PROCUREMENT SERVICES ADDENDUM

Date of Notice:	7/26/2024
Solicitation No.:	IB-001-25
Title:	Belknap Campus Roof Replacements BP-3
Addendum No.:	1

U OF L BELKNAP CAMPUS - ROOFING REPLACEMENT

SHEET TITLE: REPAIR DETAILS

15 REMOVE AND DISPOSE OF MICROWAVE DISH (STRICKLER HALL)

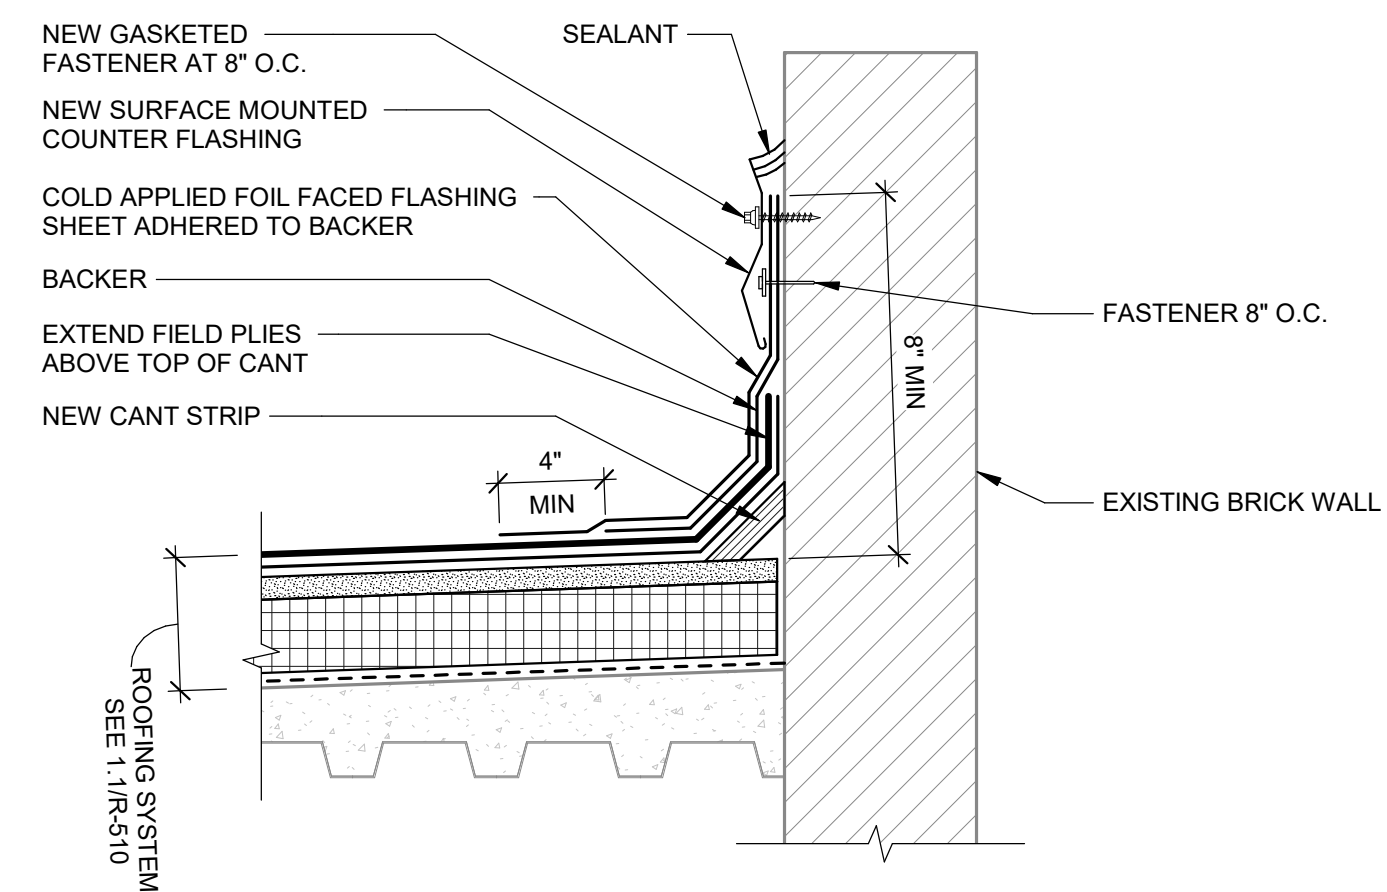
6. Can we please confirm and mark that the electrical has been disconnected for the satellite that gets removed from Strickler Hall.

University Response: The Electrical or any power connection to the satellite dish will be disconnected. Contractor to remove cables and conduits associated with it on the roof.

3.1 TYPICAL NEW ROOFING SYSTEM - ERNST ROOF A

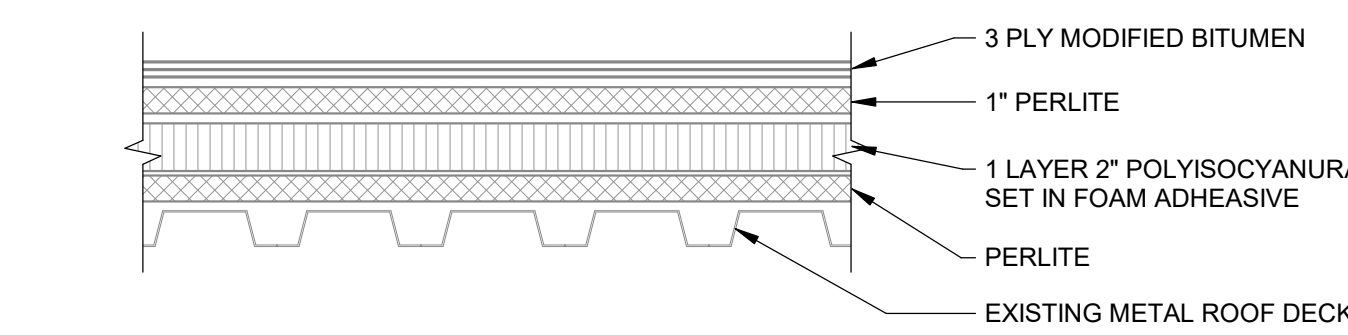
7. Roof area A on Ernst Hall has a slope of 1.5"x12. All manufacturers require that the sheets run vertical and back nailing of the base and cap.

University Response: Install pressure treated wood battens as needed to attach base, insulation, cover board and cap sheets to sloped metal deck, per the manufacturer's installation instructions.

NOTE: INSTALL PRESSURE TREATED WOOD BATTENS AS NEEDED TO ATTACH BASE, INSULATION, COVER BOARD AND CAP SHEETS TO SLOPED METAL DECK, PER THE MANUFACTURER'S INSTALLATION INSTRUCTIONS.

2.1 TYPICAL NEW ROOFING SYSTEM - BRIGMAN

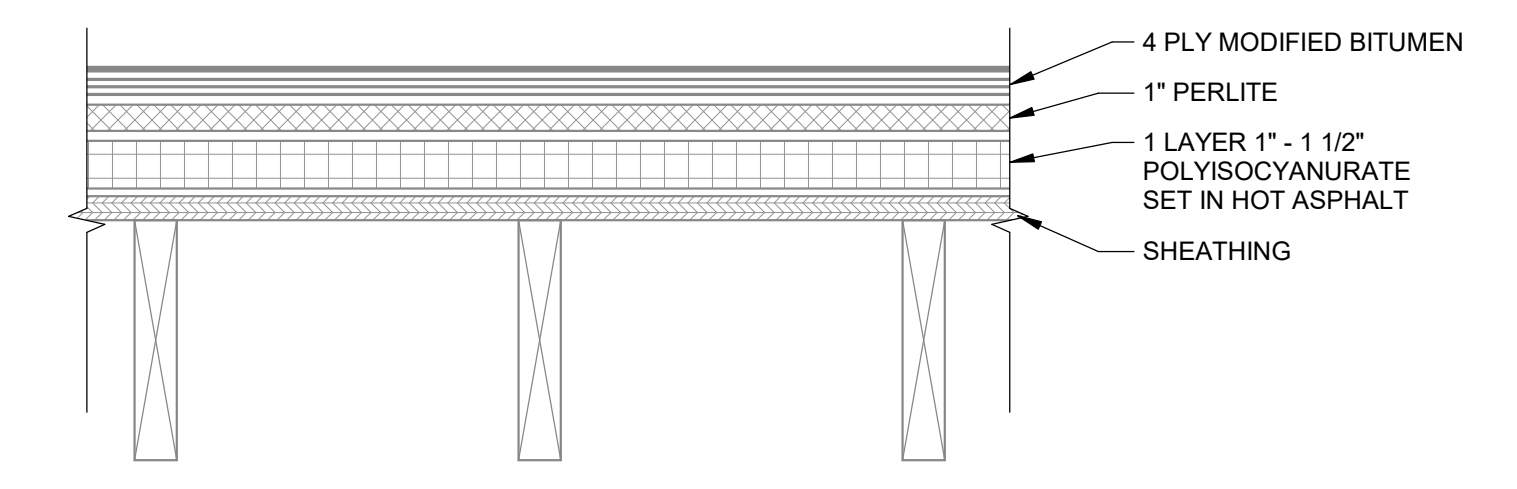
2. Details 1-4 on R-520 new roof systems call for a layer of 2" ISO and detail 2.1 calls for 1" Dens Deck. Specs call for a layer of 2.2" ISO and ½" Dens Deck. Can you please verify which is correct.

University Response: The drawings will preside. One layer of 2" insulation and ½" Dens Deck is required at each roof area at each building.

5 COPPER COUNTER FLASHING DETAIL

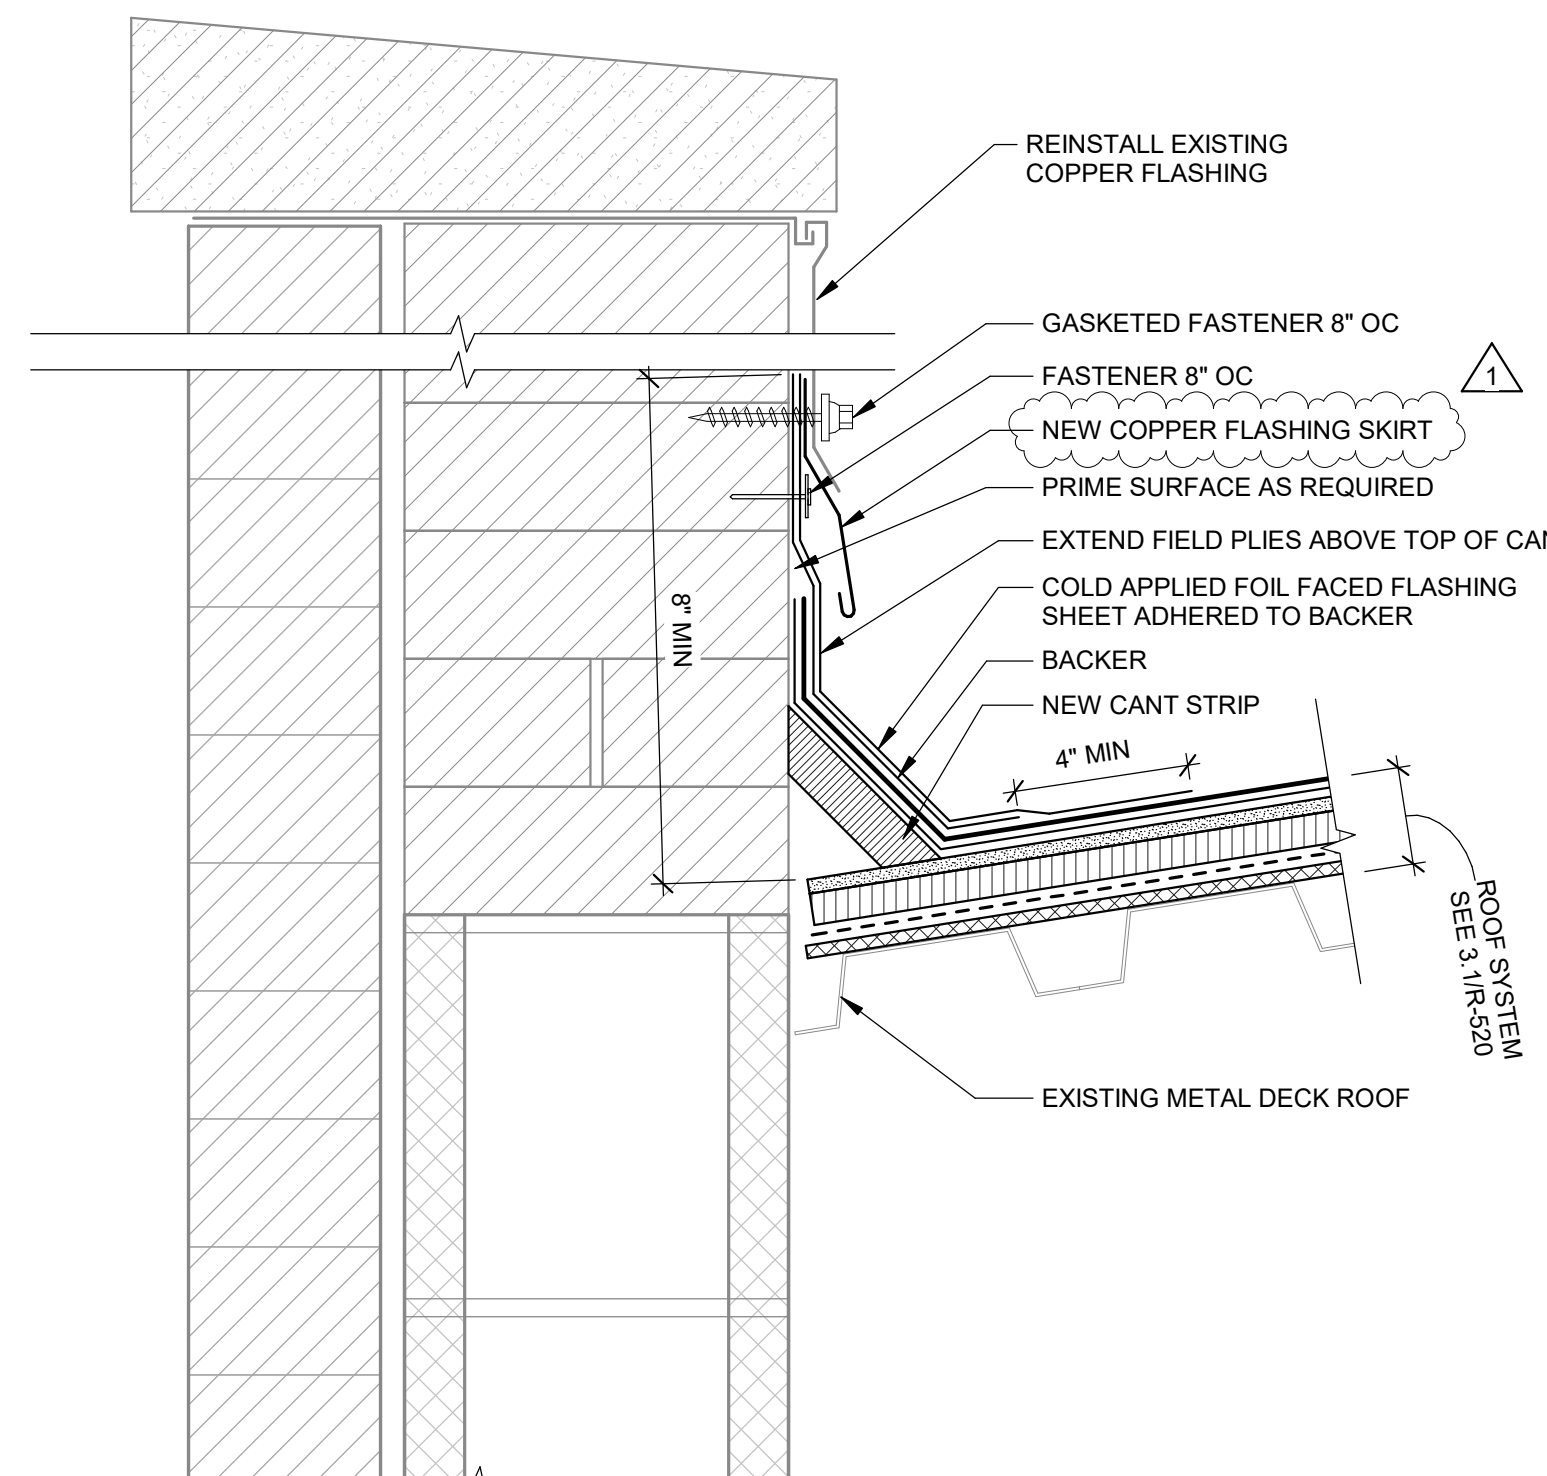
4. Detail 1, 5 and 7 on R-521 show new flashing to attach to existing copper flashing. The specs call for all aluminum flashings. Copper and aluminum aren't compatible metals. Please confirm all metals are to be aluminum.

University Response: Where new metal is in contact with existing copper, the metal flashing will be copper. Refer to specification section "07 62 00 Sheet Metal Flashing and Trim" Part 2, 2.5 Sheet Metal Fabrications for copper weight.

UNIVERSITY OF LOUISVILLE
BELKNAP CAMPUS - TUNNEL PLAN TO S&CW PLANT

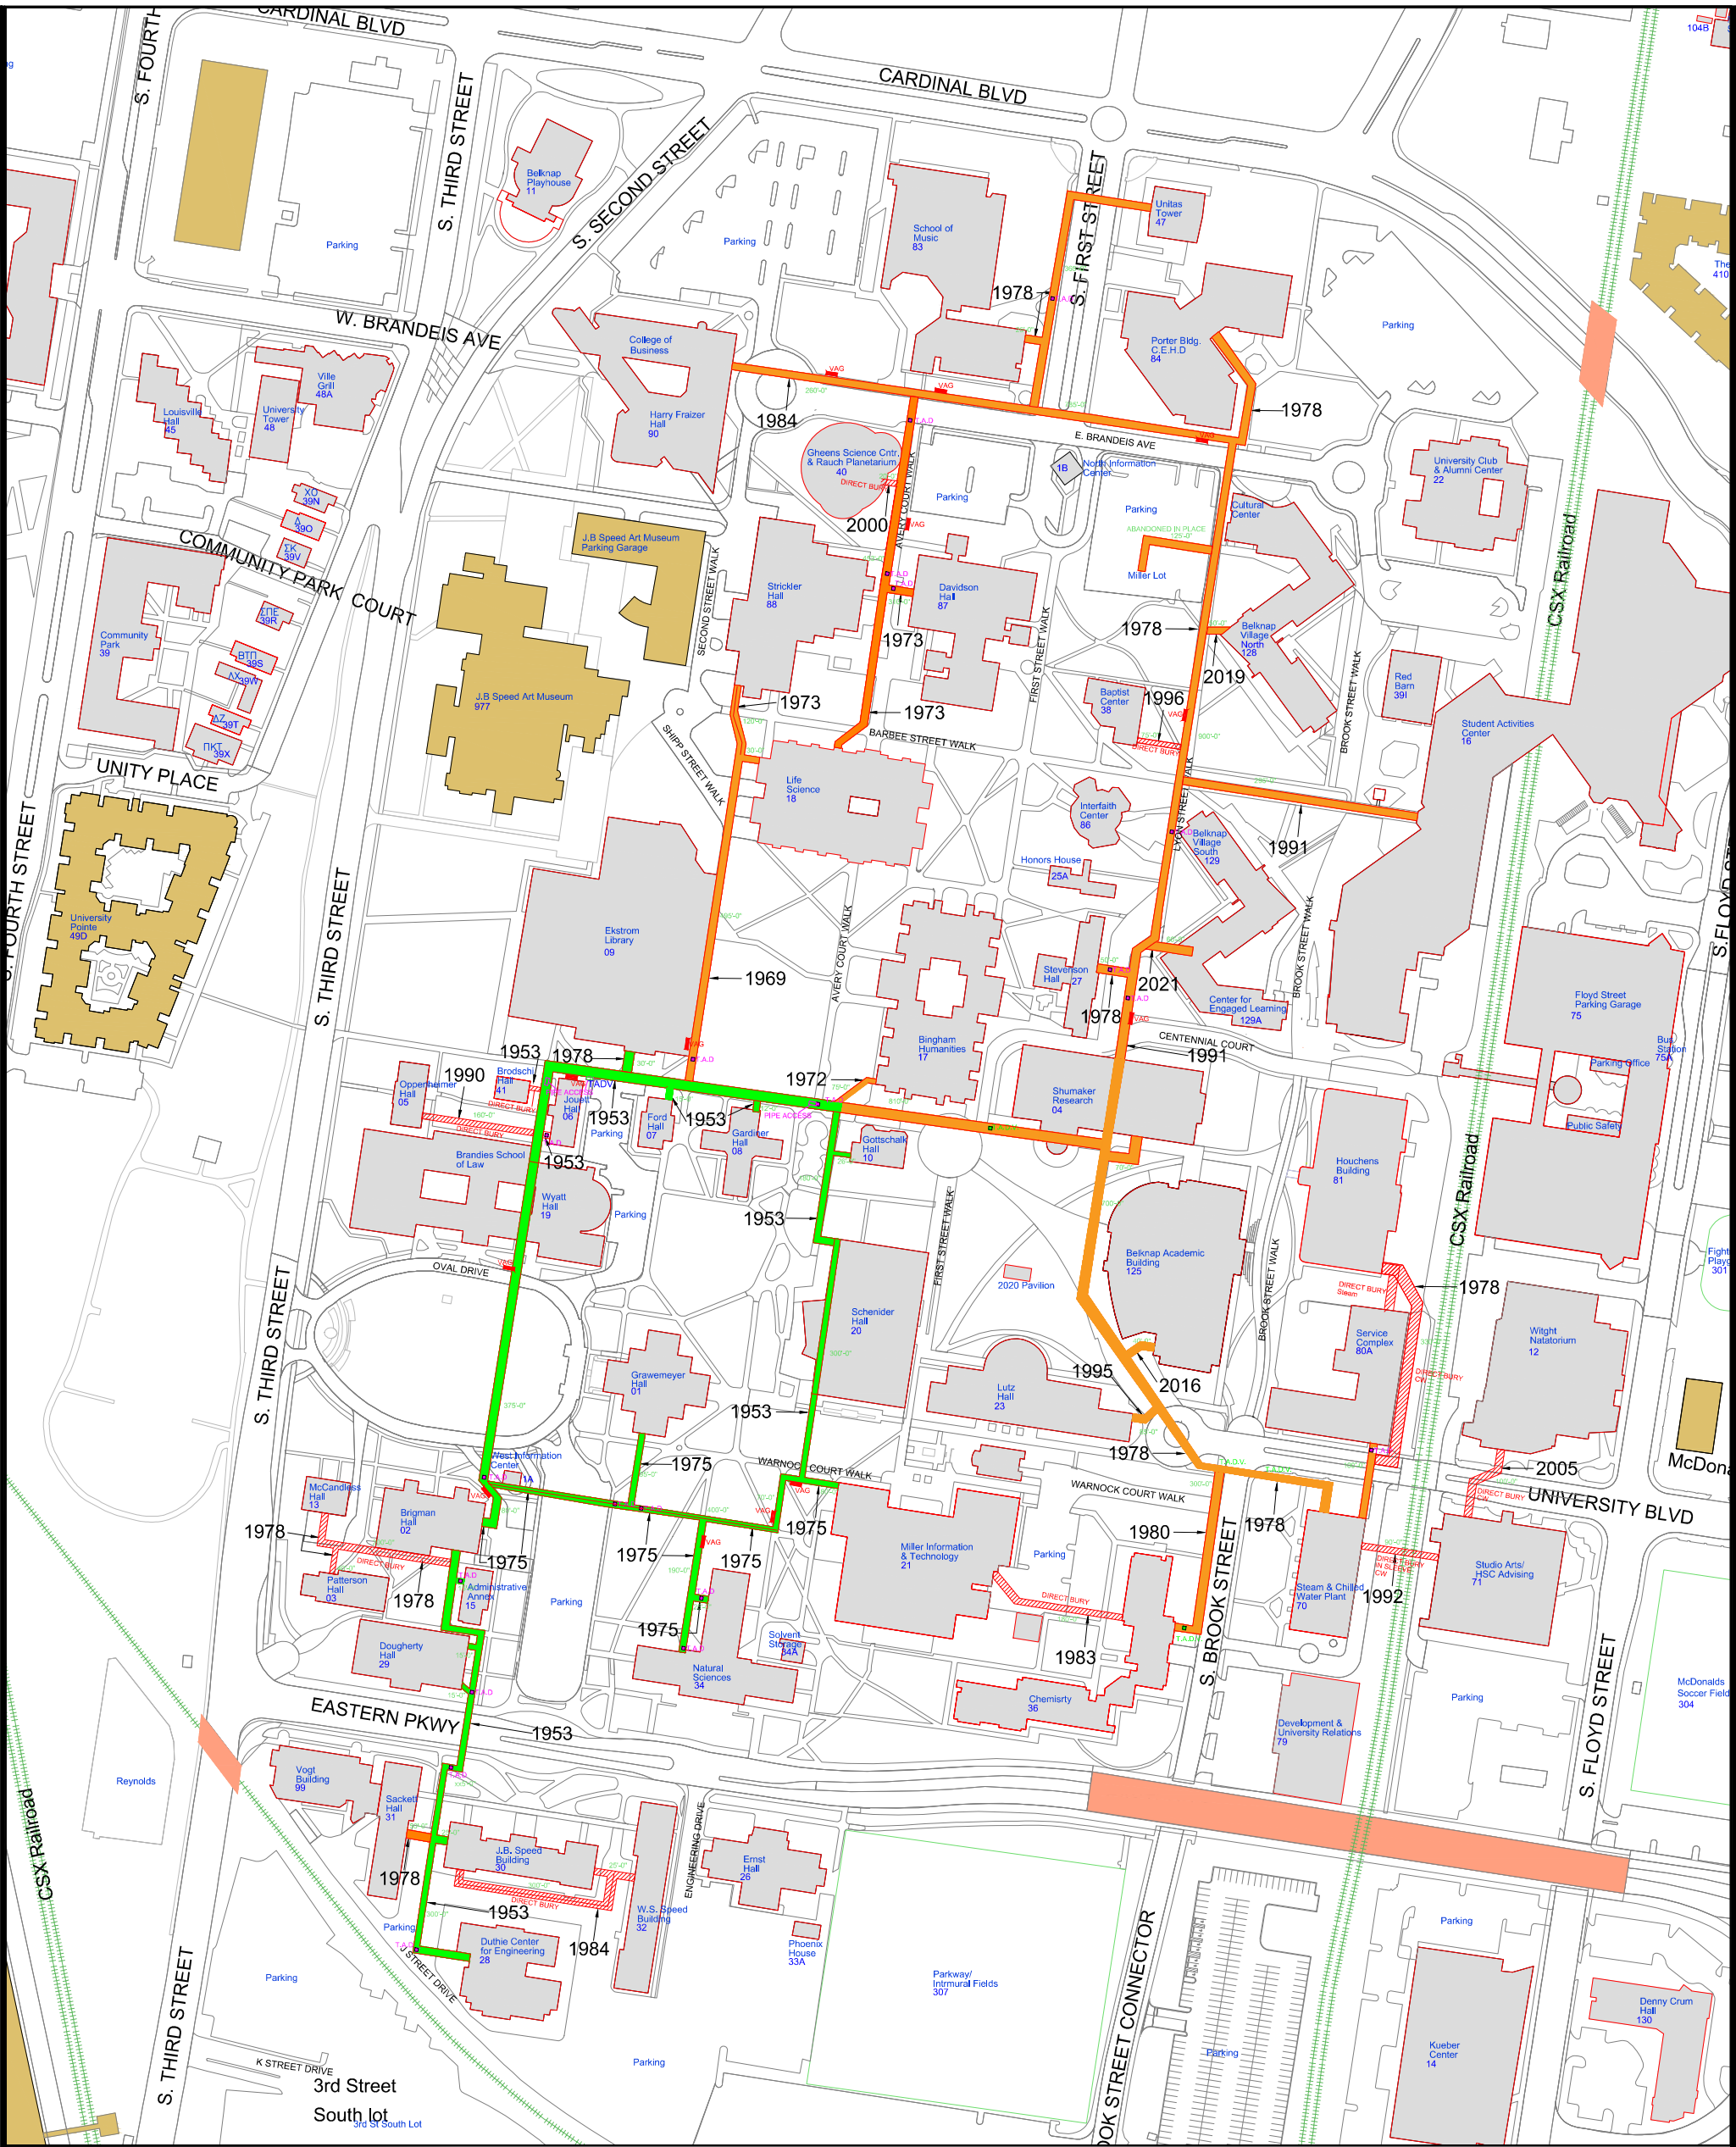
5. Can you please provide the tunnel plans for around Strickler Hall. Need to reference for crane lifting.

University Response: Please see Exhibit G (UofL Tunnel Info) below.
